Arlington Conservation Commission

Date: Thursday, May 7, 2020

Agenda

NOT TO SCALE

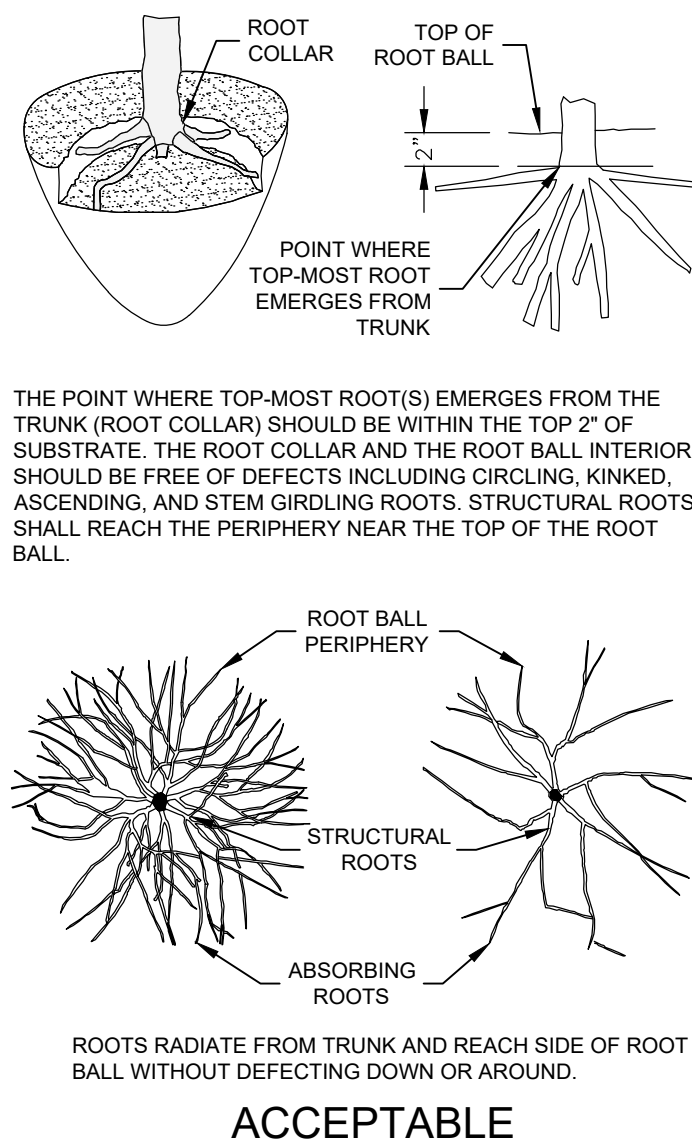
C. Tirone asked whether the grease waste container will be replaced and if additional precautions will be taken to prevent leaks in the future. C. Tirone requested an Operation and Maintenance plan for the grease waste container.

- 1) an O&M plan for the grease waste container
- 2) shrubs/plugs in addition to the grass mix proposed
- 3) amended plans with a 12" compost sock as erosion control

1. A weekly inspection record form for the subject property has been provided. See attached.
2. In addition to the erosion control matting and grass mix, Sweet Ferns (*Comptonia Peregrina*) are proposed to be planted throughout the proposed excavation area as specified on sheets C1.1 and C5.1. See the attached CZM list for details on Sweet Ferns.
3. Proposed perimeter erosion and sediment controls during construction shall be 12-inch compost socks. See sheets C1.1 and C5.1.

Attachments: Revised Site Plan Sheets
- C1.1 Site Plan
- C5.1 Construction & Erosion Control Details
Weekly Inspection Record Form
CZM Native Shrubs and Groundcovers List

Sweet Fern (*Comptonia peregrina*)

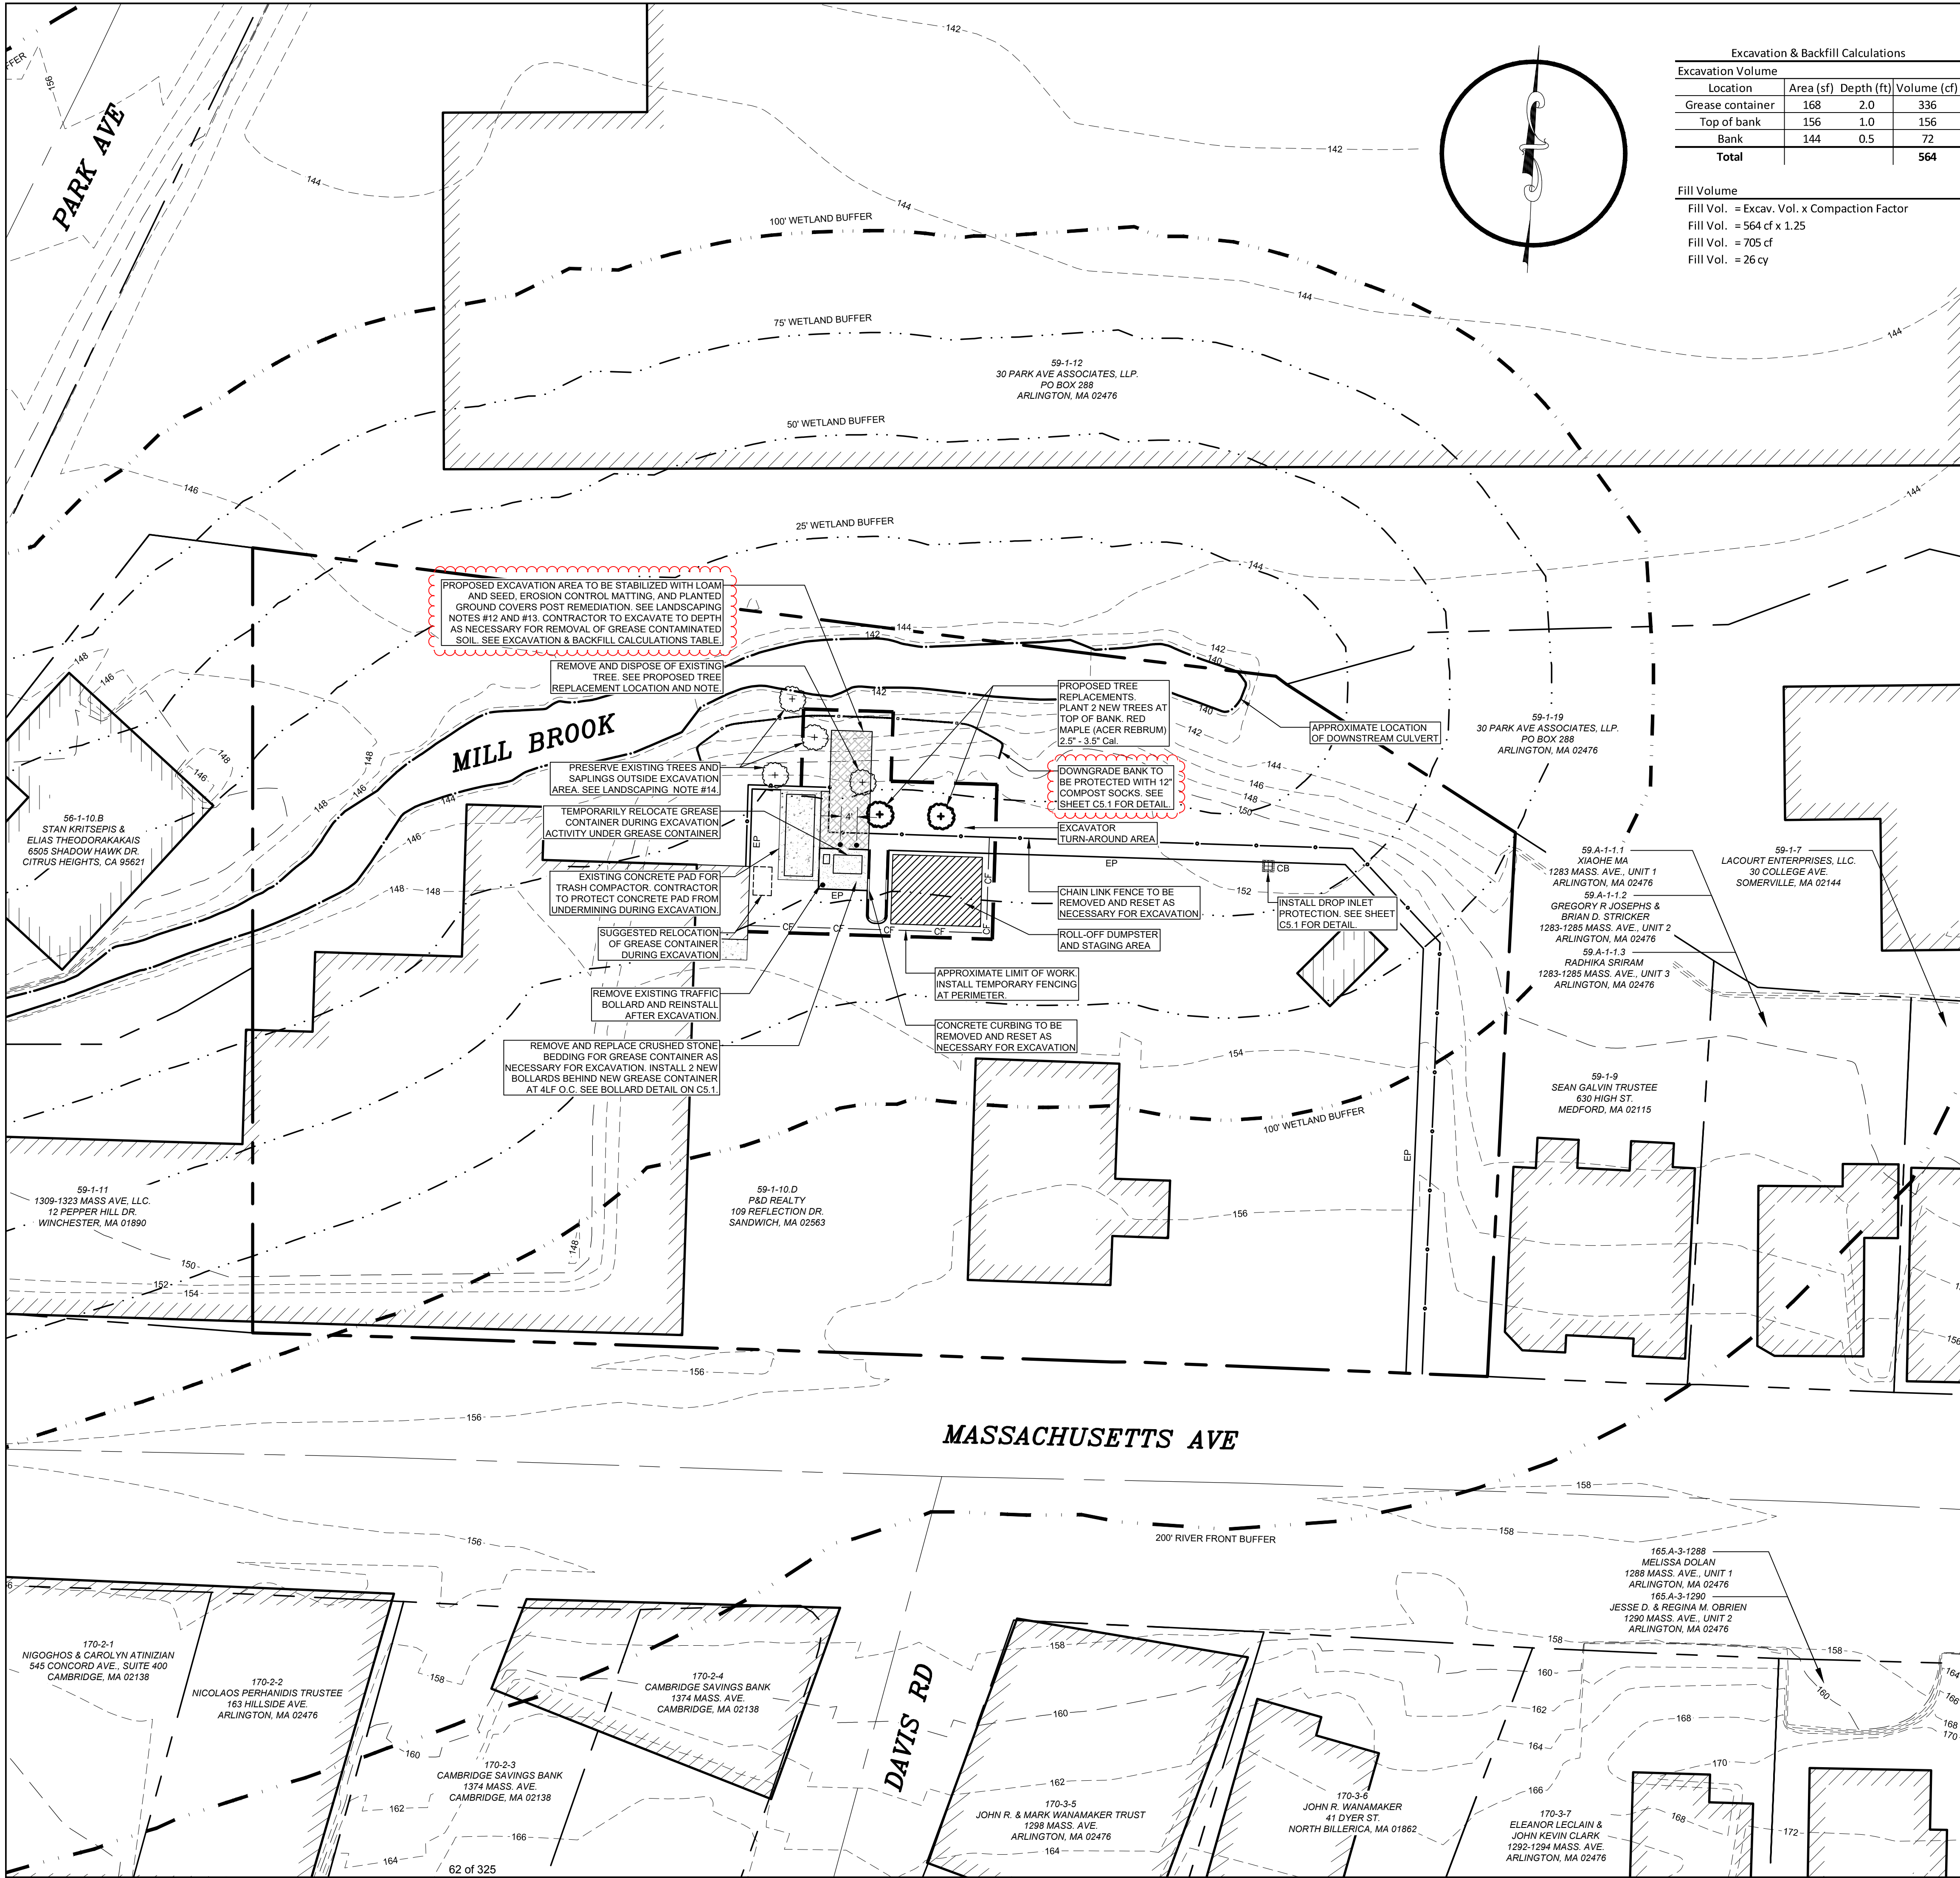
D. Kaplan stated the vegetation replacement plan should include native vegetation like shrubs, ferns, and sedges, rather than just turf. C. Garnett recommended that the native vegetation selected should have strong roots to mitigate bank erosion.

- CONTRACTOR TO USE SWEET FERNS (COMPTONIA PEREGRINA) FOR ALL GROUND COVER PLANTINGS. SWEET FERNS SHALL BE PLANTED WITHIN THE EXCAVATION AREA NORTH OF THE EXISTING CHAIN LINK FENCE AND SPACED AT 2 FT TO 3 FT. SEE SHEET C5.1 FOR INSTALLATION DETAILS.

3 POROUS PAVER DETAIL
C-1 SCALE: NTS (WALKWAY)

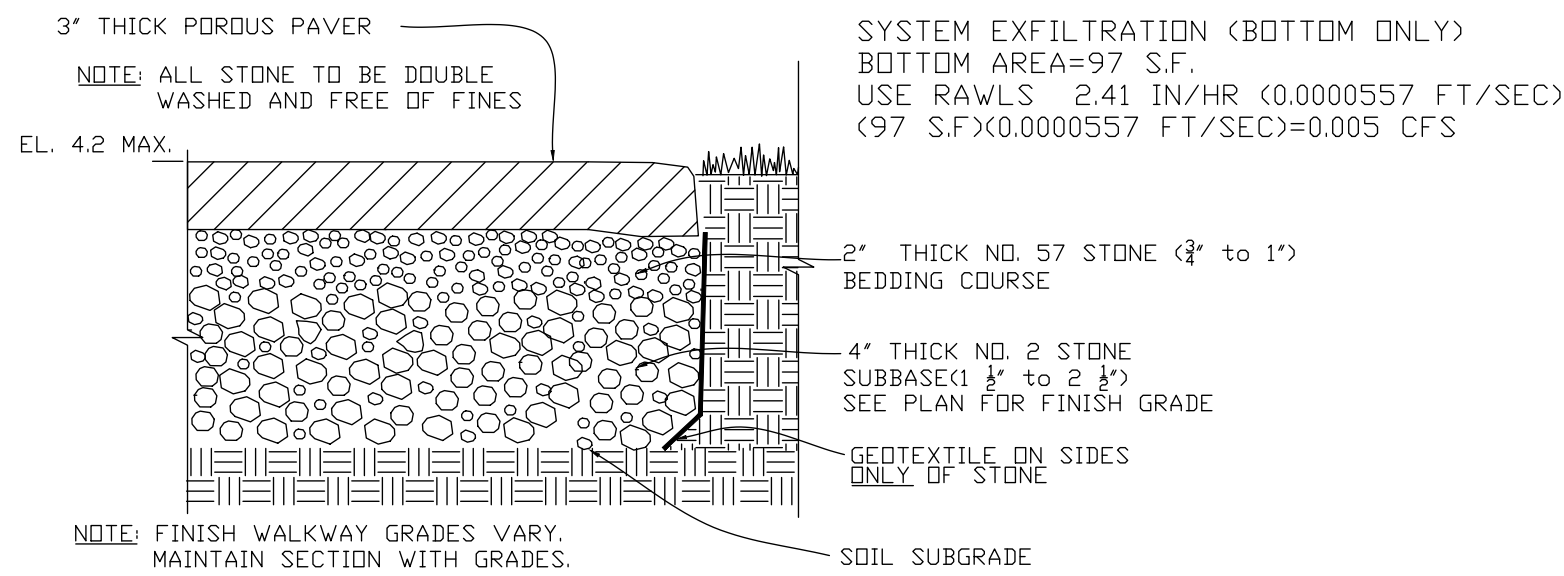
The Commission reviewed the supplemental material. D. Kaplan asked if the proposed pervious pavers had any details and specifications. E. Sullivan shared the details and specifications with the Commission.
